City of Portland
CRC Design Refinements
Flexible Service Work Order

DRAFT FINAL
FINDINGS REPORT

July 7, 2010

Work Order No. 36670-1

Figure 1
Schematic Lane Drop at Hayden Island for
Northbound Scenario 2

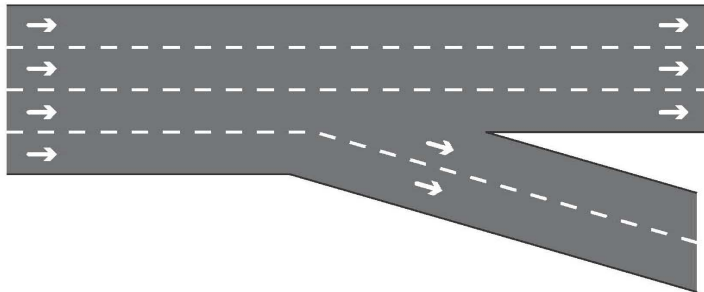
This concept was developed in response to the City’s desire to explore alternative ways of reducing auxiliary lanes as I-5 approaches the bridge. In this scenario, the northbound entrance from Victory Boulevard would be carried along I-5 as an auxiliary lane but unlike LPA Phase 1, it would be dropped at Hayden Island (Ramp 5N-HI), as indicated in **Figure 1**. I-5 would continue as three lanes toward the northbound entrance from Marine Drive, which would join the mainline as an auxiliary lane. These four lanes would then be joined by a fifth lane, the northbound entrance from Hayden Island. Exhibit A in **Appendix B** depicts the detail at this entrance location. Lane 5 would be carried as an auxiliary lane to the Mill Plain exit where it would be dropped. This would yield a configuration of five northbound lanes over the bridge. The overall lane configuration for NB Scenario 2 is shown in **Figure 2**.

2. North of the exit to Hayden Island, I-5 would contain four lanes under NB Scenario 1 and three lanes under NB Scenario 2. This reduced mainline capacity under NB Scenario 2 would need to be evaluated in the CRC traffic model to determine whether it is a critical constraint.

- NB Scenario 2 could result in improved operations over NB Scenario 1 by virtue of the continuous flow of Hayden Island traffic as it enters the freeway. Further traffic modeling analysis would be needed to confirm this potential benefit and, accordingly, whether NB Scenario 2 should be retained for further design development.

Figure 3
Schematic Lane Drop Prior to CD Merge
for Southbound Scenario 2

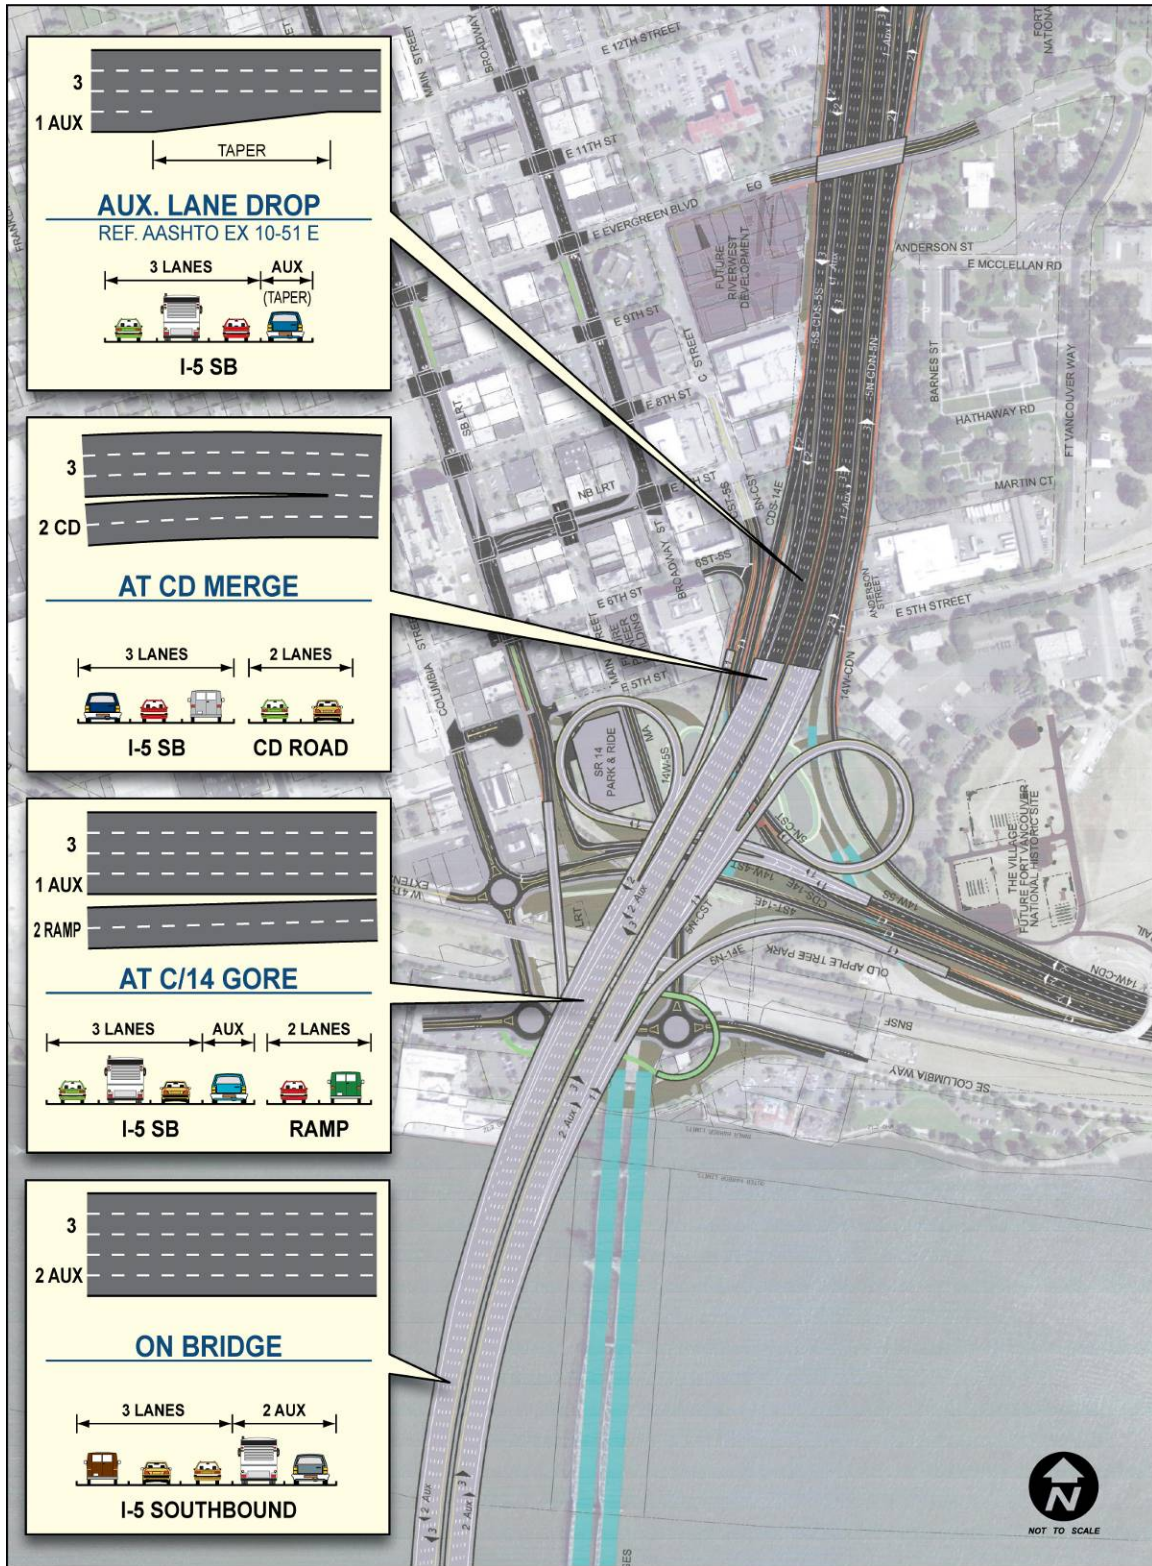
2. The Lane 4 auxiliary lane drop proposed under SB Scenario 2 would be the trade-off for the SR 14 auxiliary lane on the bridge. I-5 traffic in Lane 4 would need to maneuver left approaching the tapered merge. However, the distance available for this maneuver and advance signing would begin downstream from the SR 500 entrance.

This concept is illustrated in **Figure 3** below. The AASHTO guideline (Exhibit 10-51 and related text) for merging the SR 500 auxiliary lane is also included as **Figure 4**.

- SB Scenario 2 could result in improved operations over SB Scenario 1 by virtue of the continuous flow of SR 14 traffic as it enters the freeway. Further analysis is underway by CRC project staff to confirm this potential benefit and accordingly, whether NB Scenario 2 merits further consideration for design development.

Figure 7
 CRC LPA Phase 1: 10-Lane Design
 (5 Lanes Southbound Across Columbia River)

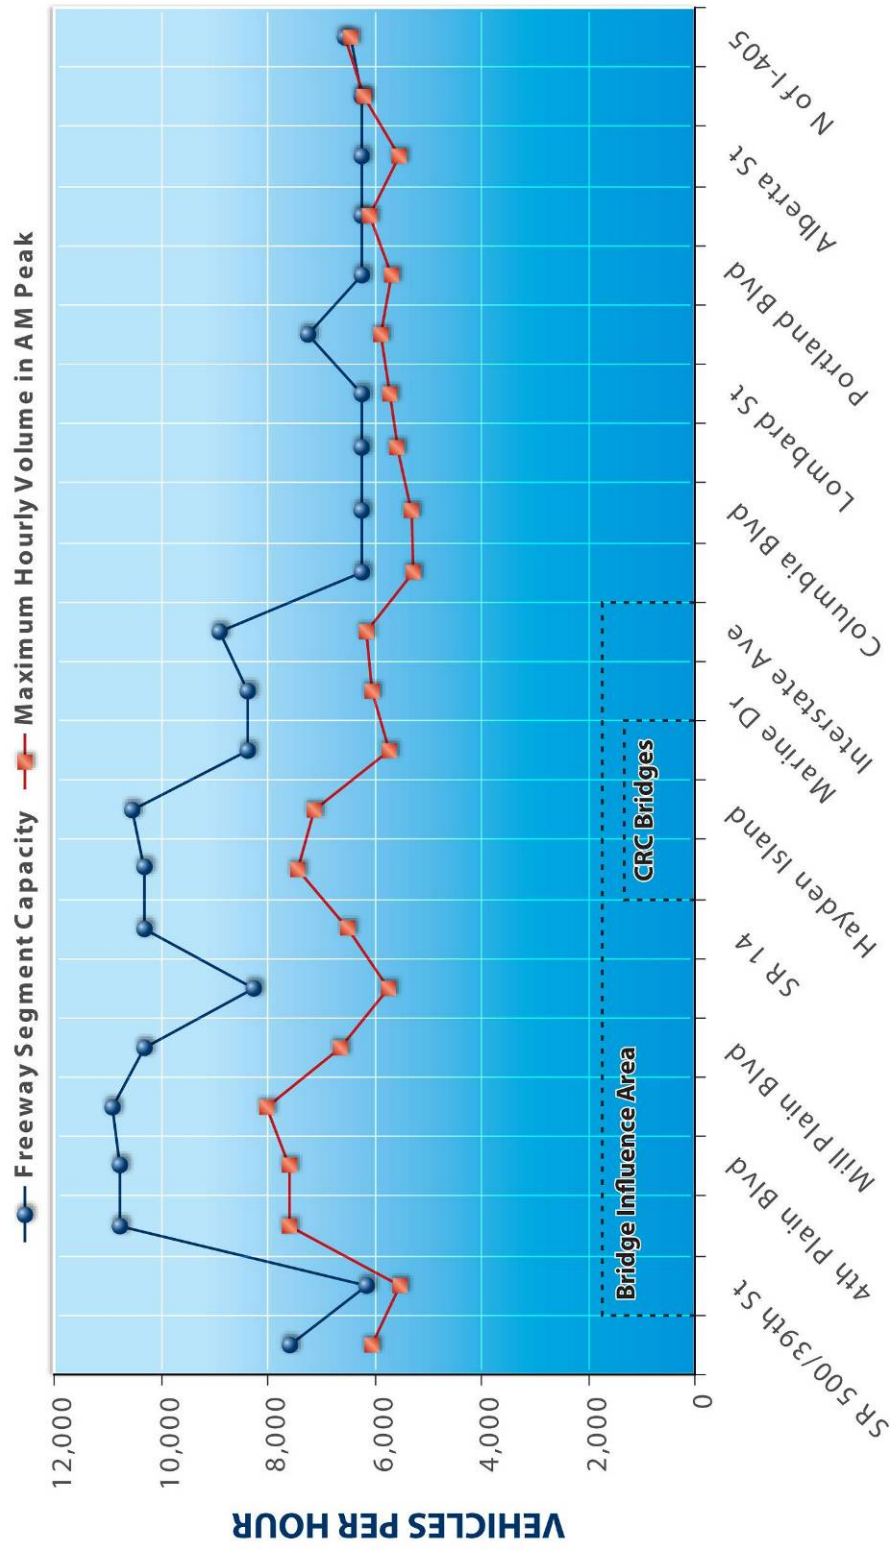
With respect to weaving, the HCM 2000 specifies reduced capacities for weaving segments less than 2,500 feet in length. For the initial analysis, we assumed that only the location south of Going Street contains a weave less than 2,500 feet. For this Findings Report, the figure has been updated to include weaving considerations in the southbound direction.

- I-5 southbound north of the I-405 split is identified as a bottleneck location with at-capacity traffic demand within a weaving area, under both No-Build and LPA conditions. The segment on I-5 southbound from Going Street on-ramp to I-405 off-ramp is a Type C weaving area (one weaving maneuver requires at least two lane changes) according to HCM 2000. As illustrated in **Figure 7**, with LPA built the forecast traffic demand on I-5 southbound between Going Street and I-405 is very close to the estimated capacity.

Figure 8
Cross Sections of Existing
CRC Refinement LPA Phase 1 and LPA Full Build
(10- and 12-lane bi-level main spans)

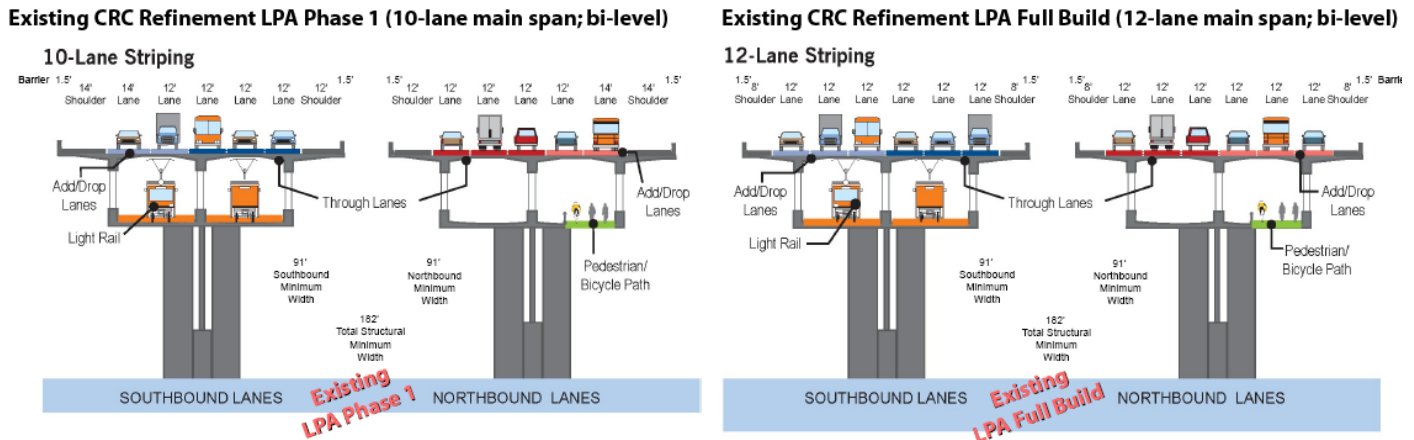
There are ramp tapers on the river crossing structure that increase these nominal widths. Based on information provided by CRC, the upper deck area for the 12-lane Columbia River Crossing bridge with this arrangement is 557,700 square feet.

The Phase 1 LPA 10-lane facility proposed by CRC is “overbuilt” to provide the flexibility of future restriping to a future permanent 12-lane facility. A refinement of this option could be to provide an initial 10-lane facility that does not allow future restriping to 12 lanes. This arrangement is shown below as the CoP 10-lane permanent main span, and represents a 4’ width savings for each deck as compared to the proposed CRC Phase 1 LPA 10-lane section. A further refinement would be to provide an 8-lane facility, also shown

Figure 9
Cross Sections of
City of Portland Refinement Options
(8- and 10-lane bi-level main spans)

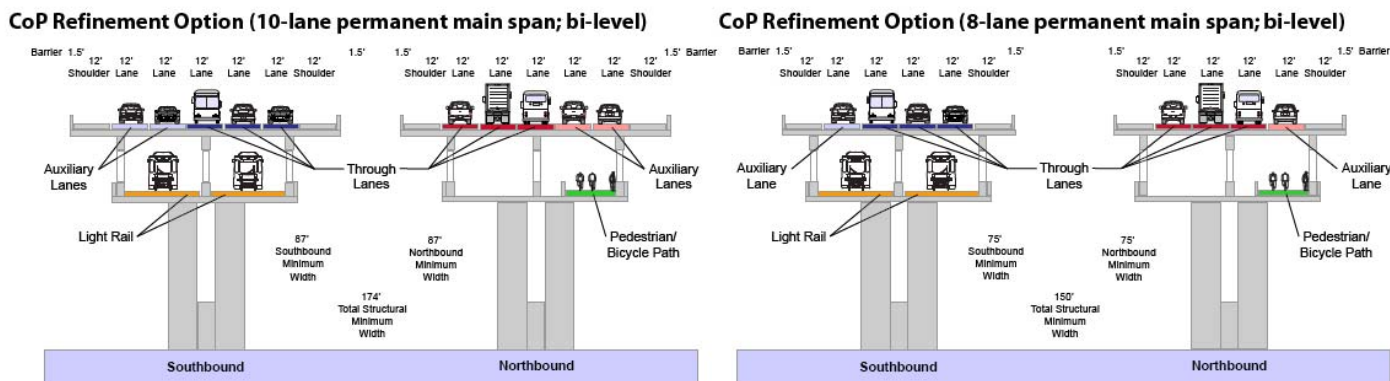
below. The 8-lane facility would represent an additional 12' width reduction for each deck from the CoP proposed permanent 10-lane section. These refinement options are shown in Figure 9.

The table below summarizes the potential bridge cost savings of these refinements. The bridge cost includes both the savings for the river crossing bridge and the approach bridges on each side of the river. There would also be additional roadway and interchange related savings, which are not addressed here.

**Figure 10
Cross Section of
City of Portland Refinement Option
(10-lane single-level main span with separate LRT/pedestrian/bike structure)**

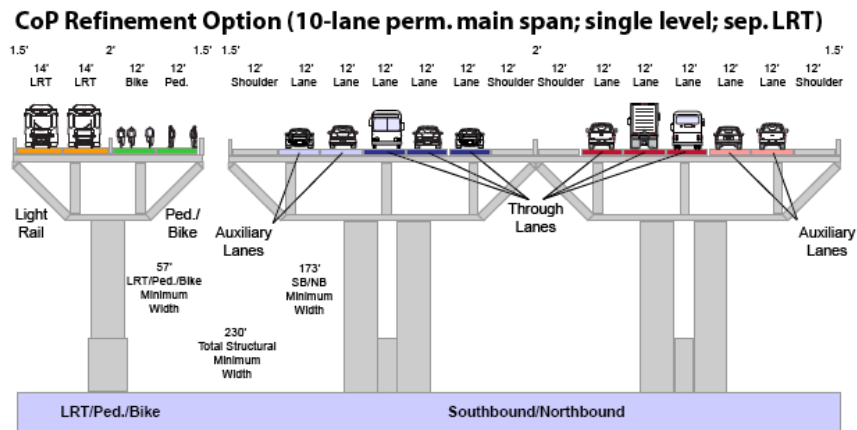
It should be recognized, however, that there may be different cost risks between these two bridge types that could result in a much greater cost differential favoring the more conventional segmental concrete box girders. See the “Critique of Current Open-Web Box Girder Main River Bridge” section below for more detail.

- c. From a design viewpoint, the deflection criterion for bridges carrying pedestrians and for LRT is more stringent than that for conventional vehicular traffic. Therefore it makes some sense to place the LRT and pedestrians on a separate structure, designed for the more stringent deflection criteria. This will result in some incremental cost savings for the bridges carrying only the vehicular traffic. This savings is not included in the above cost comparisons, as the estimates are not presently at the level of detail to capture this refinement.

Figure 12
Cross Section of
City of Portland Refinement Option
(10-lane bi-level main span, single structure)

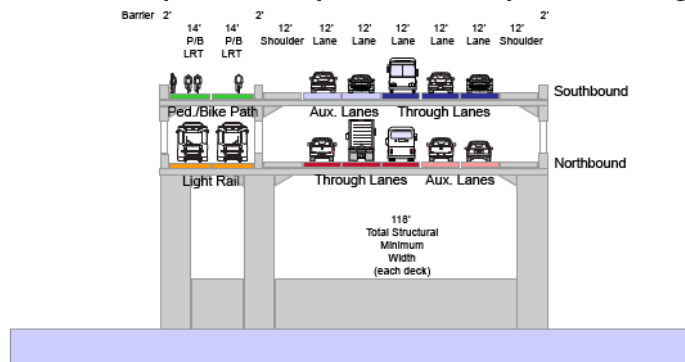
Other lane configurations, such as the arrangement shown in **Figure 12**, have been suggested that accommodate all of the traffic components on a single structure. Although possible, it is not expected that this type of arrangement would be structurally economical. Large transverse spans are required to accommodate the 5-lane traffic arrangement and the unsymmetrical longitudinal supporting members would not lead to an economical design.
